3.7 WATER RESOURCES AND WETLANDS COMMENTS AND RESPONSES

3.7.3 Comments and Responses

Figure 3.7-1 Town Wetland & Watercourse Control Area (Buffer) Disturbance Map
 Stateline Retail Center
 Town of Southeast, Putnam County, NY
 Source: Insite Engineering, Surveying & Landscape Architecture, P.C.
 Drawing Date: November 24, 2008
 Scale: As shown

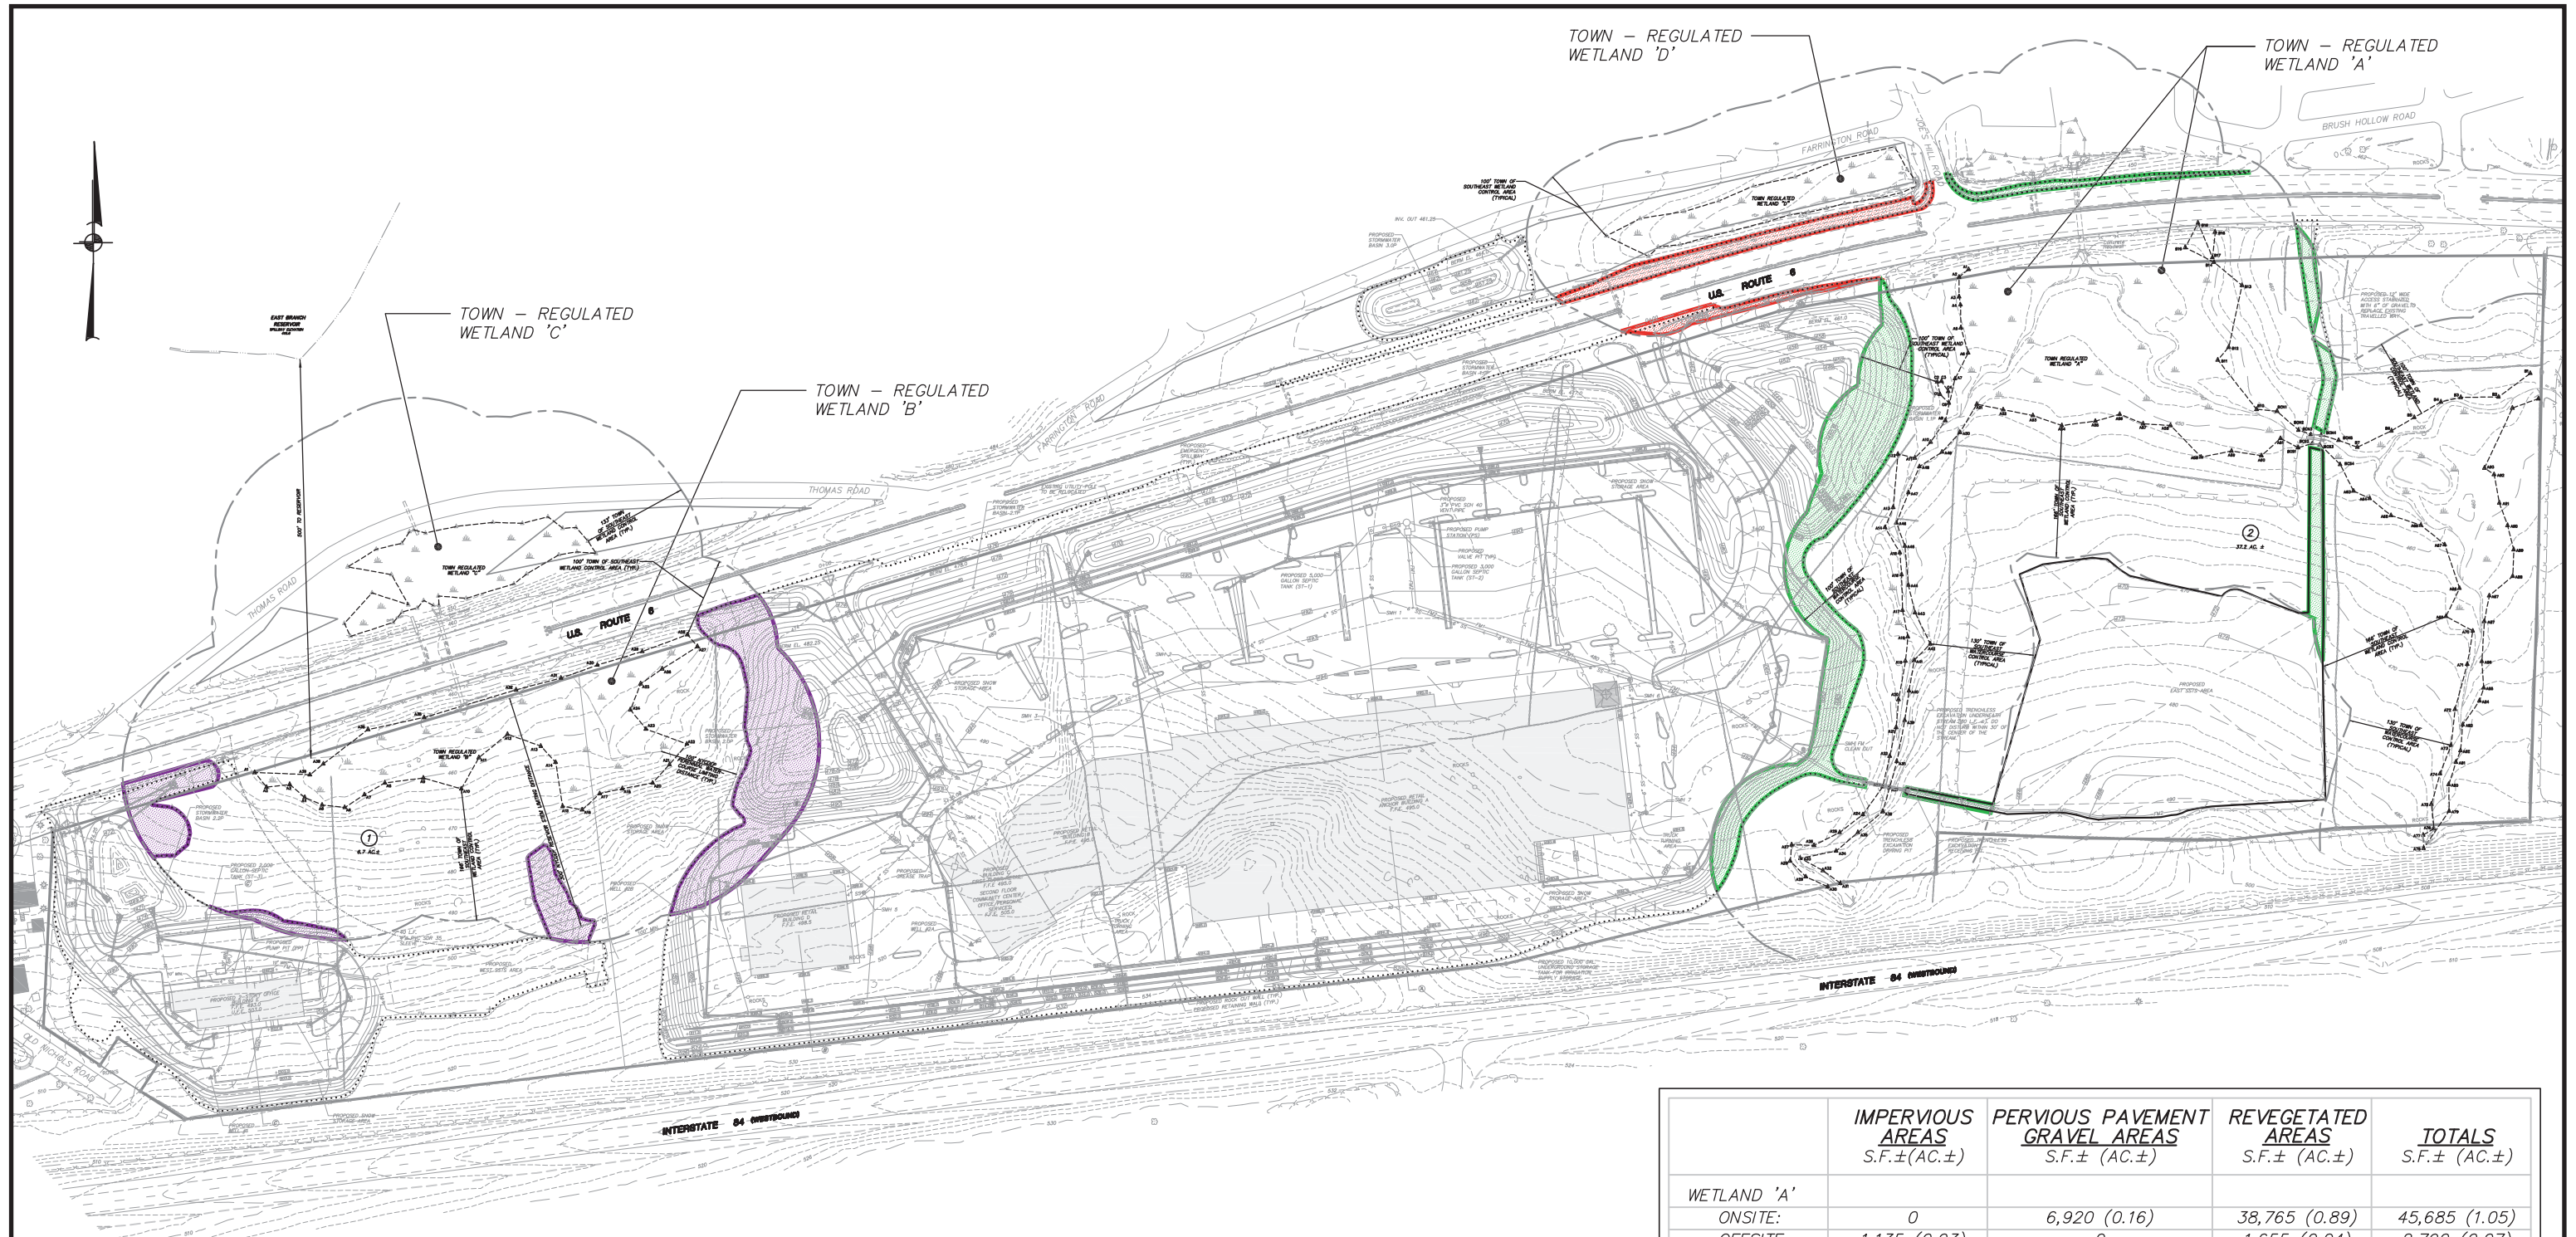
Comment 3.7-7 (AKRF, Letter #4, September 29, 2008): A figure showing proposed improvements superimposed on watercourse and wetlands and their regulated buffers would be useful. This figure should highlight the proposed location and extent of disturbance within the buffers.

Response 3.7-7: A figure showing proposed improvements superimposed on watercourses and wetlands and their regulated buffers has been prepared and is included in the FEIS; refer to Figure 3.7-1, Wetland Control Area (Buffer) Disturbance Map.

Figure 3.7-5: Wetland - Watercourse Control Area (Buffer) Enhancement Plan
 Stateline Retail Center
 Town of Southeast, Putnam County, NY
 Source: Insite Engineers, 11/20/08
 Scale: 1" = 200'

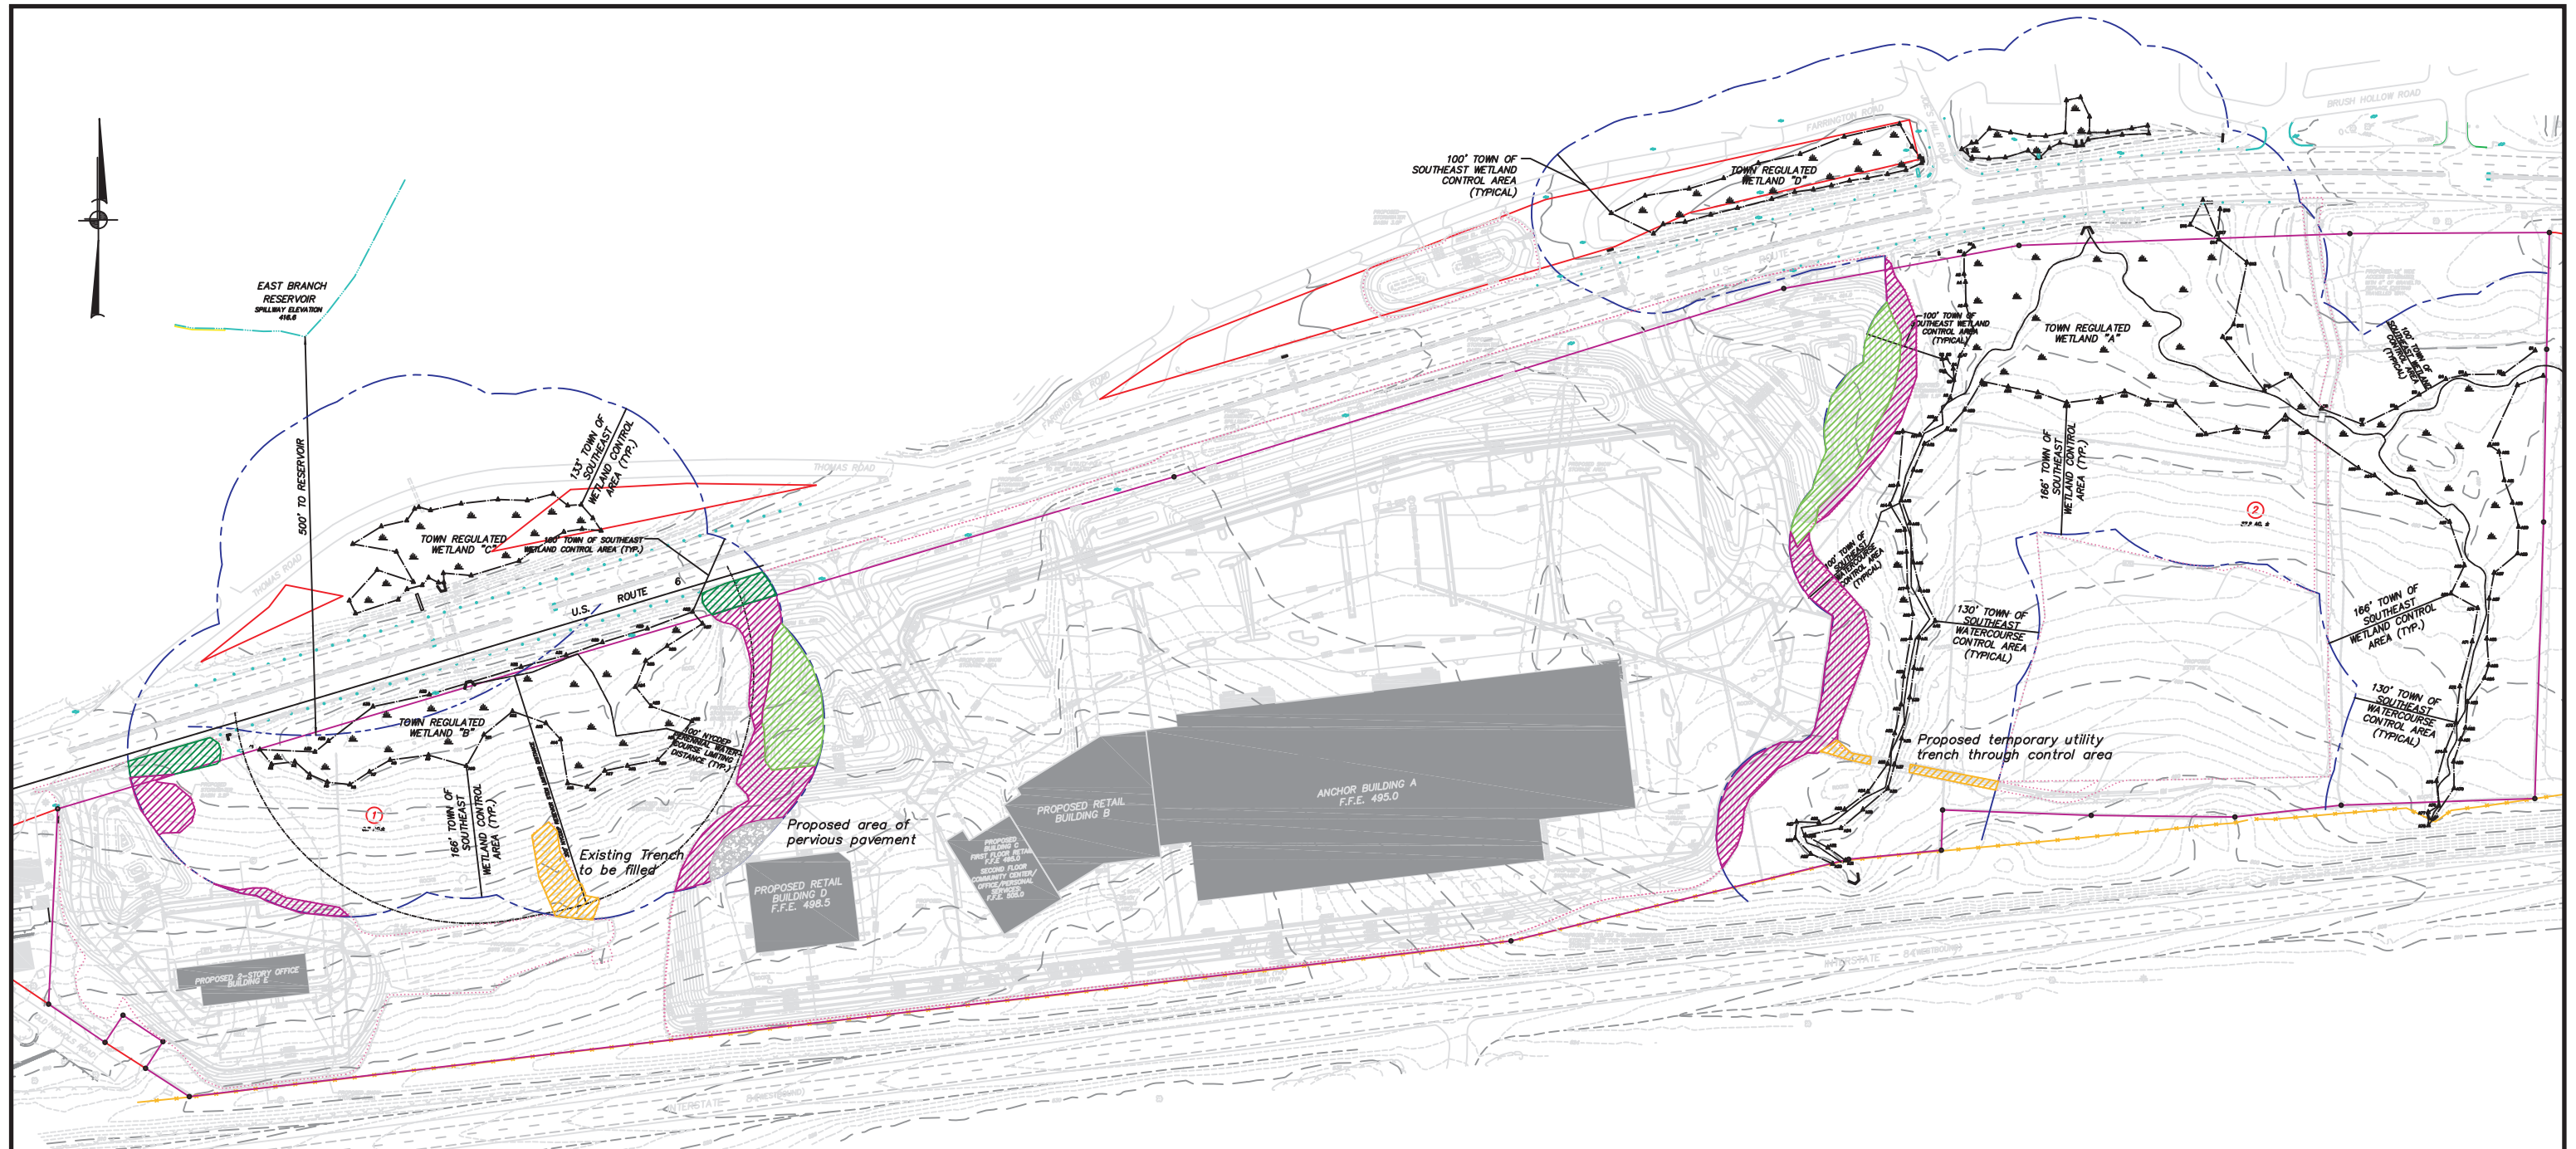
Regarding storm water detention basins 2.2 P, 2.0P; Alternate designs should be investigated in an effort to eliminate or further reduce the proposed incursions into the wetland controlled areas. Given the topography in this region of the site, it would appear that minor modifications to the shape of these basins could, at a minimum, reduce the amount of buffer disturbance.

Response 3.7-3: *The Stormwater Pollution Prevention Plan has been updated to comply with the requirements of Chapter 10: Enhanced Phosphorus Removal Standards from the New York State Stormwater Management Design Manual due to the new rainfall data from Chapter 10. As a result certain stormwater management basins had to be enlarged. While this was the case for 2.0P and 2.2P both basins were modified to reduce impacts to the Town regulated buffer to the greatest extent practicable. Basin 2.0P was revised so it is located 100’ from the NYCDEP perennial watercourse, and 2.2P was re-graded and is now completely outside the buffer area.*
